RFP 170457/ME - ADDENDUM 3

- Addendum 3 is attached. This Addendum revises the purchase and installation of all security devices from:
from: Owner Furnished / Owner Installed
to: Contractor Furnished / Contractor Installed.**

ADDENDUM NUMBER THREE

MD Anderson Cancer Center
El Rio Infrastructure Updates
MDACC Project No. 17-0457
CH+P Project No. 18-024

A4 SCHED OF OFOI SCOPE
NO SCALE

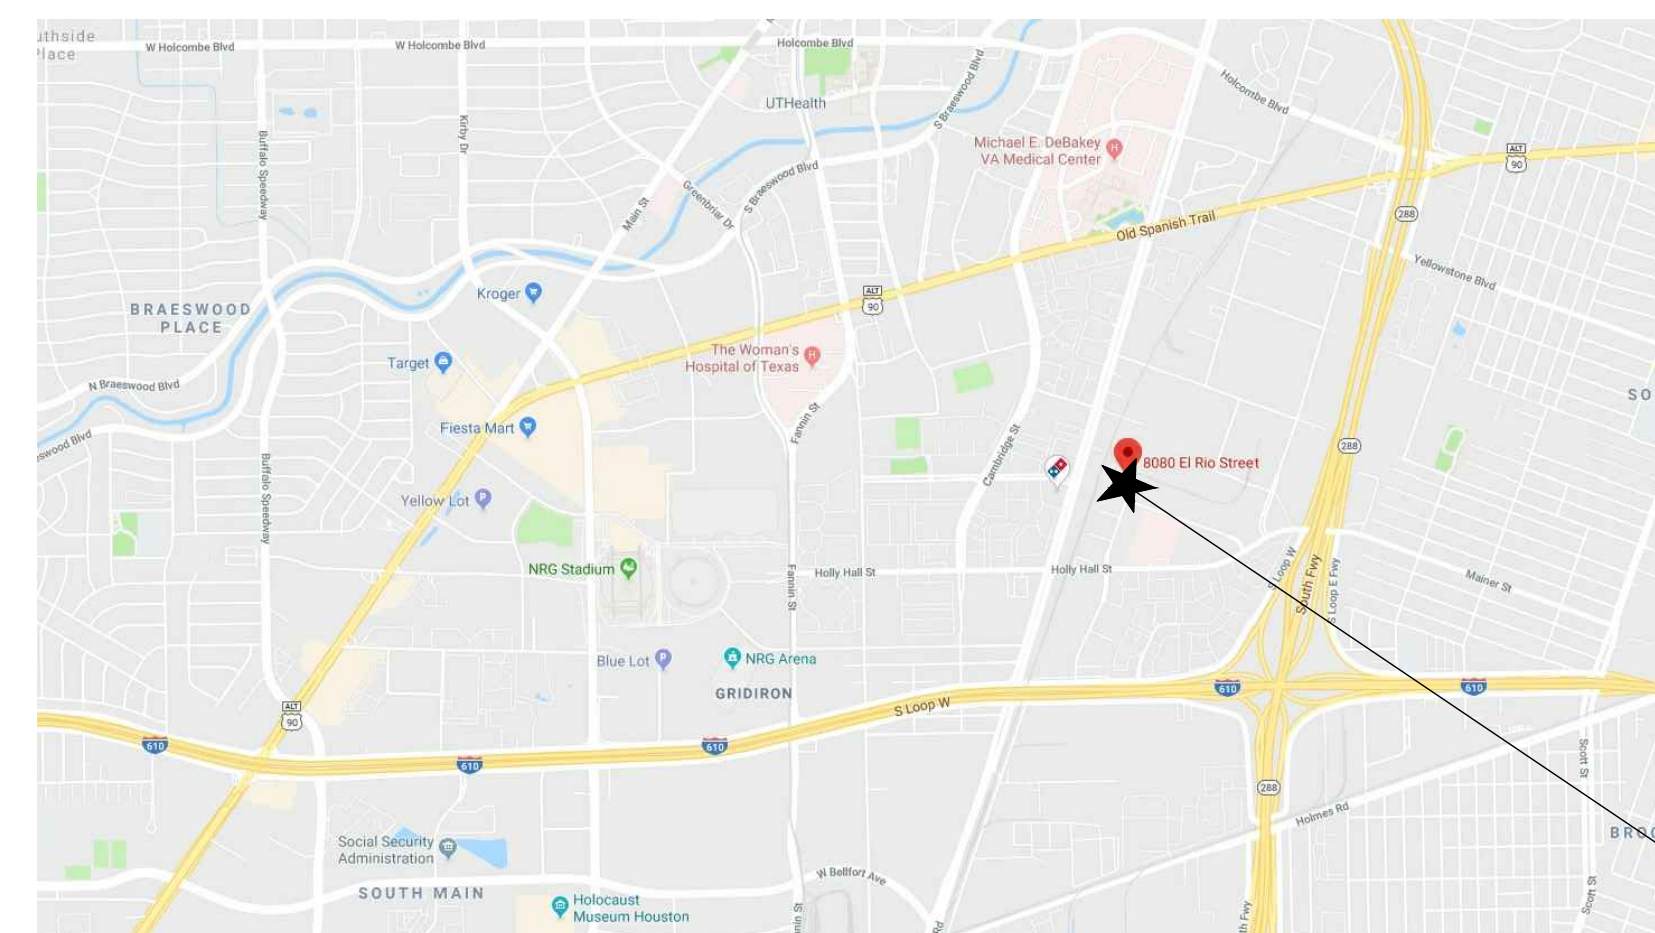
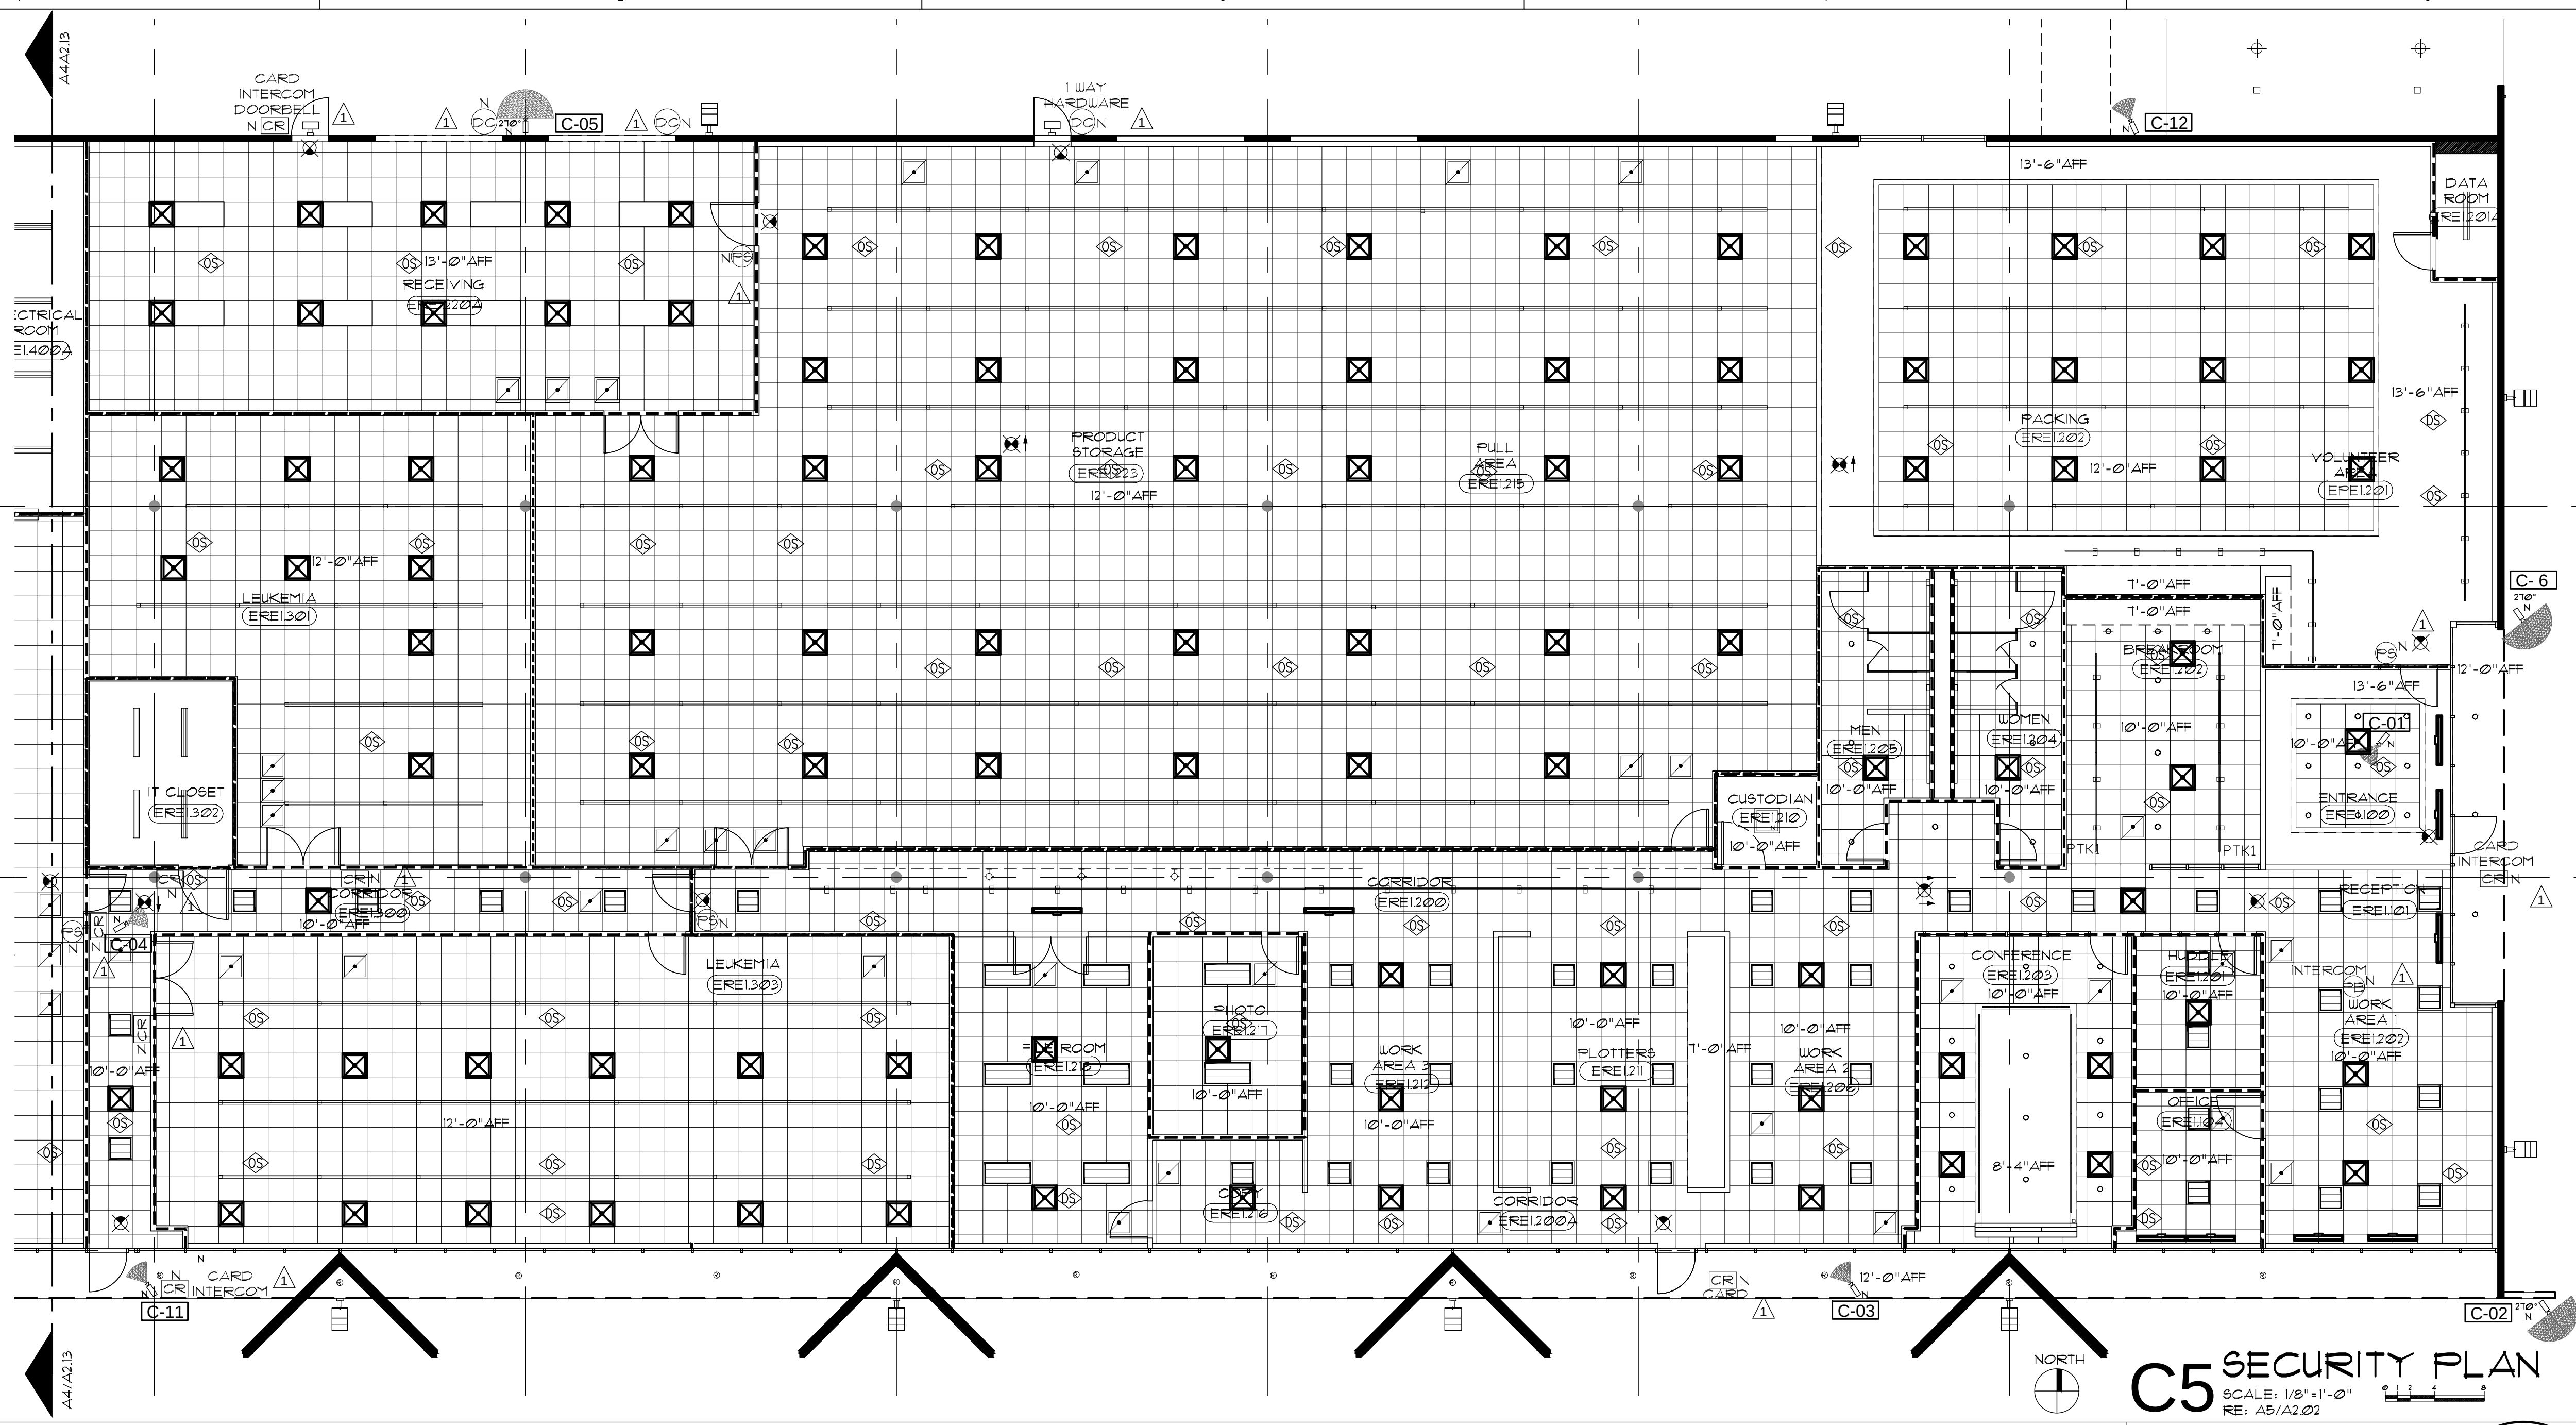
3.01 Sheet A.0.01 Index, Symbols & Abbreviations, etc . Remove and replace this sheet with the attached A.0.01. Revisions are clouded and noted as "Addendum No. 3."

C. SECURITY. GC TO PROVIDE & INSTALL A COMPLETE SECURITY SYSTEM AS SCHEDULED & SPECIFIED. THE SYSTEM INCLUDES: ACCESS CONTROL, SECURITY EQUIPMENT, PERIMETER DETECTION, CABLEING FOR CARD READERS, PERIMETER DETECTION, FULL STATIONS, DOOR CONTACTS, AND ALL SECURITY EQUIPMENT INCLUDING BUT NOT LIMITED TO ACCESS CONTROL, PANELS, CAMERAS, CARD READERS, MANAGERIAL DEVICES, DETECTORS, DETECTORS, AND INTERCOM / AIPHONES. INFRASTRUCTURE INCLUDING CONDUIT, PULL STRINGS & JUNCTION BOXES. RE. A213 FOR SECURITY. GC TO PROVIDE THE LOCATIONS & QUANTITIES OF THE SECURITY DEVICES.

SHEET:
A2.13
OF

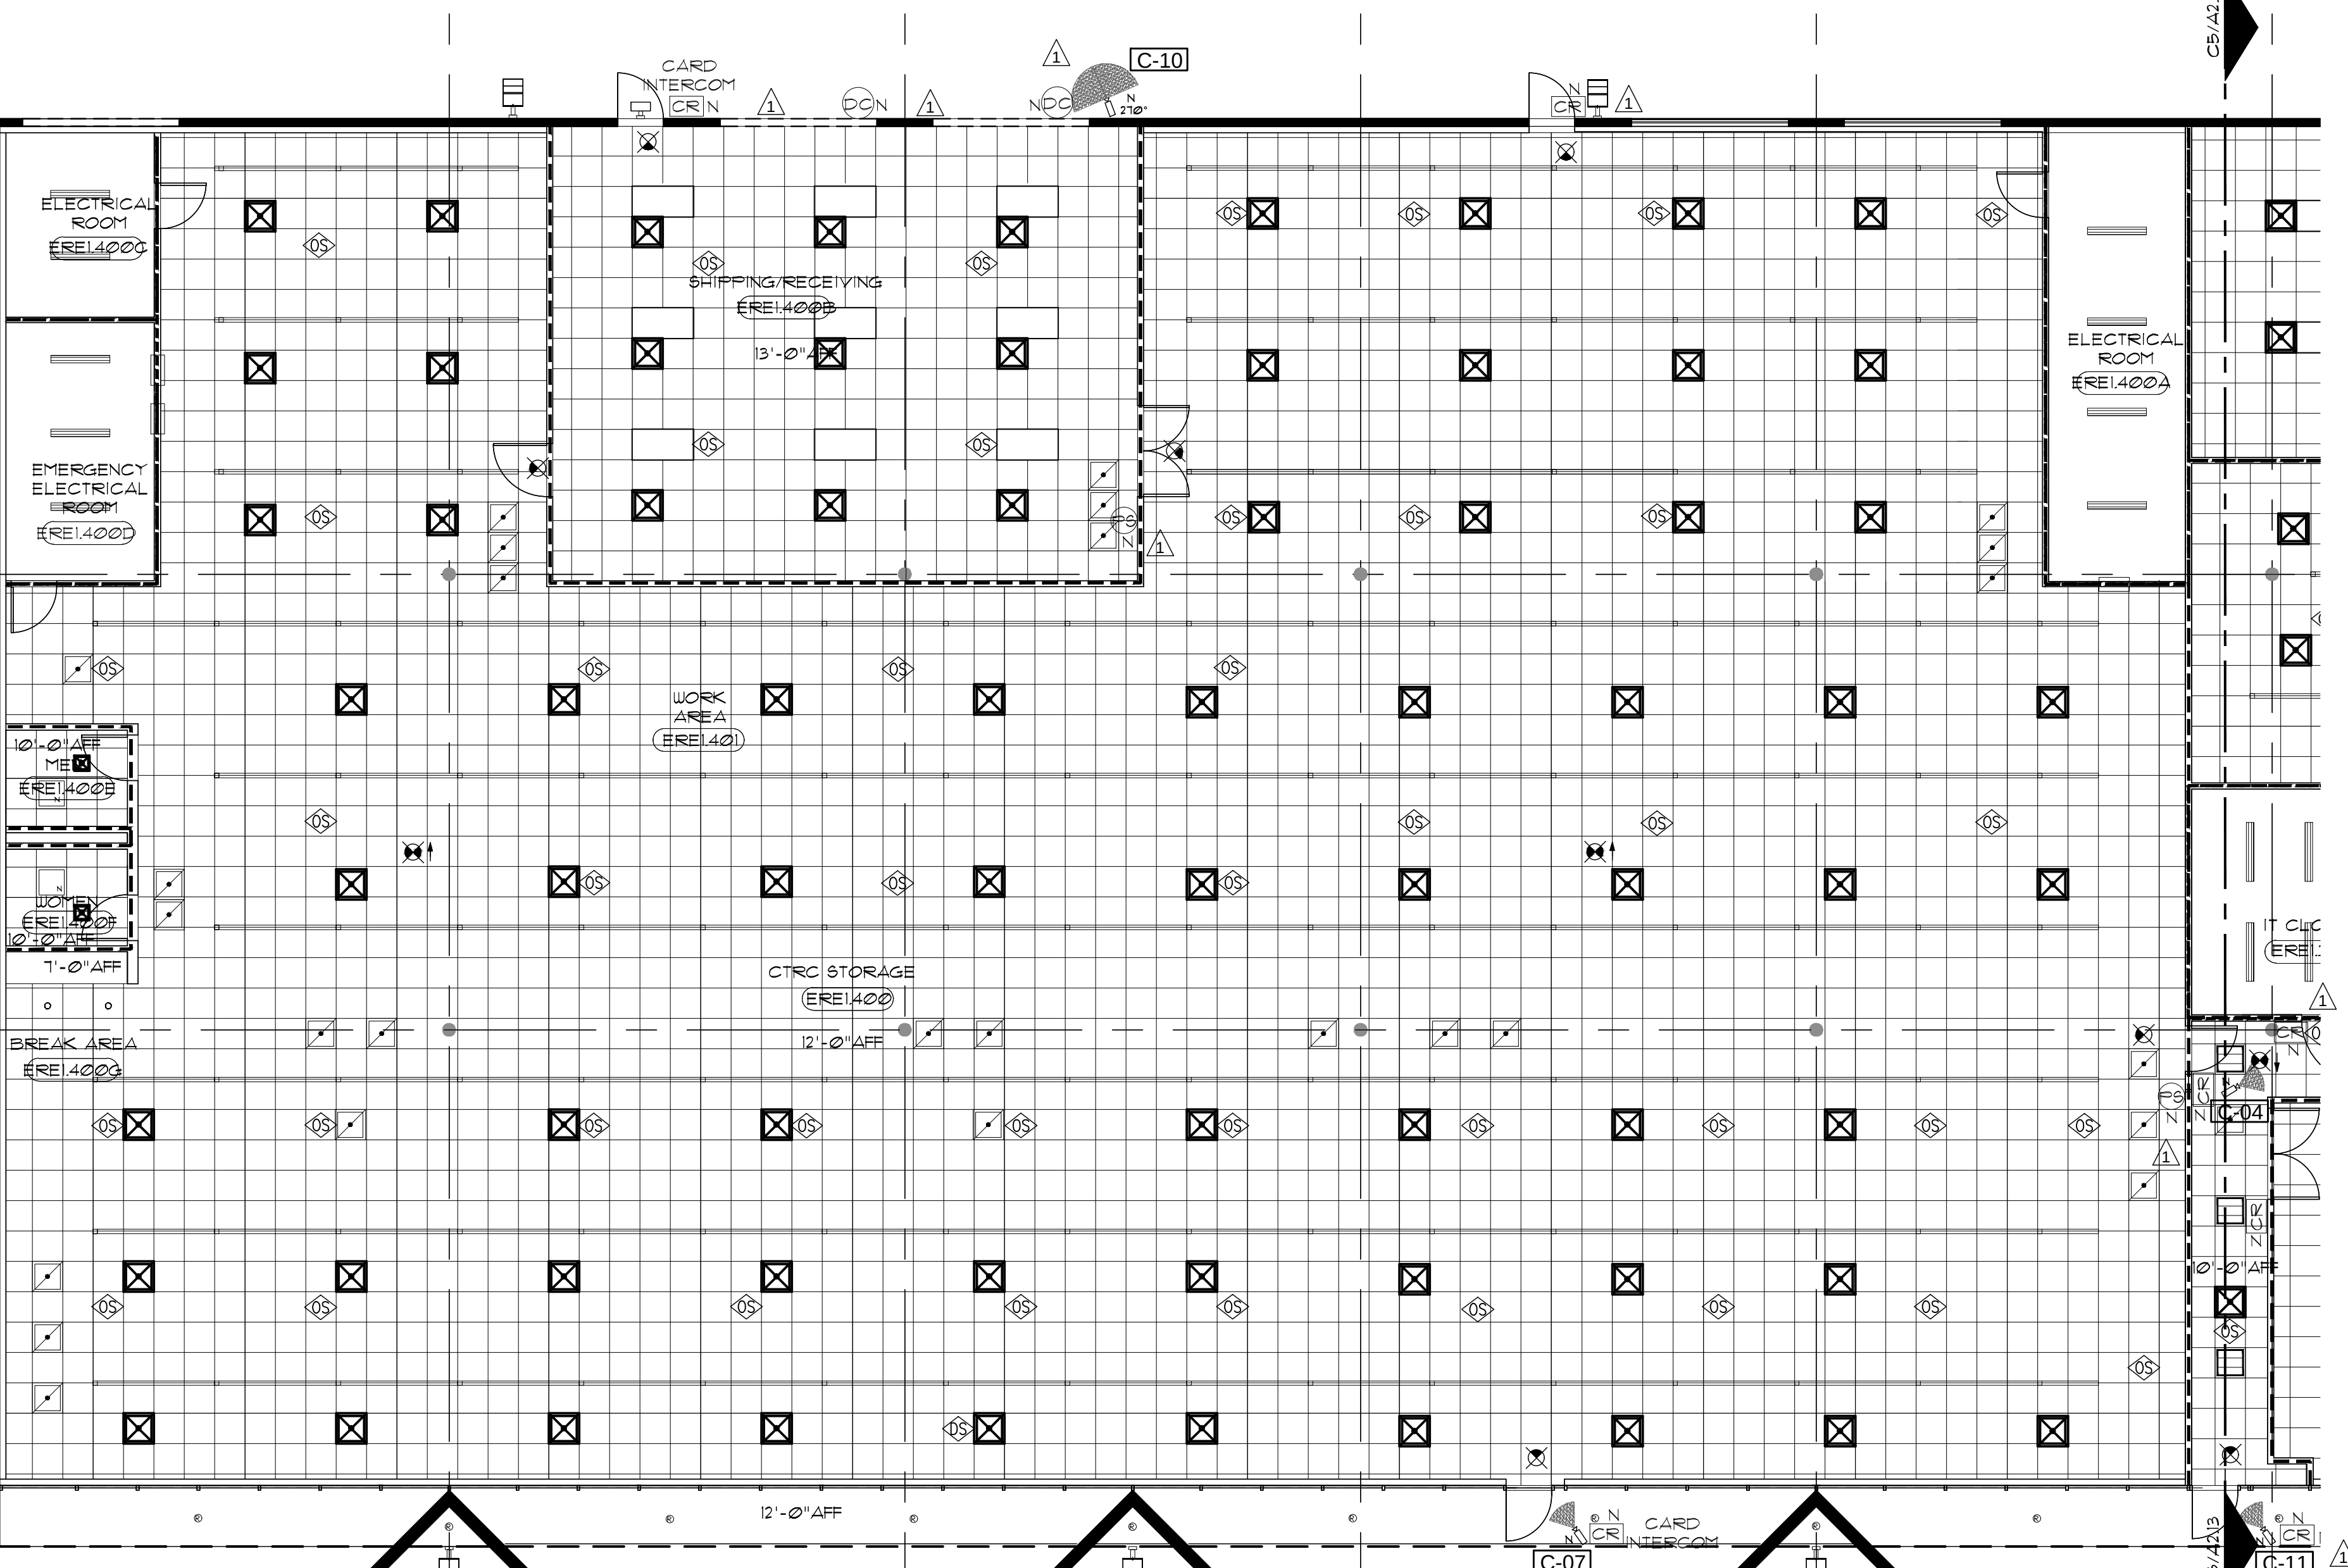
3.02 Sheet A.2.13 Security Plan. Remove and replace this sheet with the attached A.2.13 Security Plan. Revisions are clouded and noted as "Addendum No. 3."

- GENERAL NOTES**
- A. THE G.C. WILL PROVIDE & INSTALL ALL SECURITY DEVICES & SECURITY CABLING. DEVICES INCLUDE CAMERAS, FULL STATIONS, CARD READERS, DURESS/PANIC BUTTONS/DOOR CONTACTS/INTERCOM & LAP.
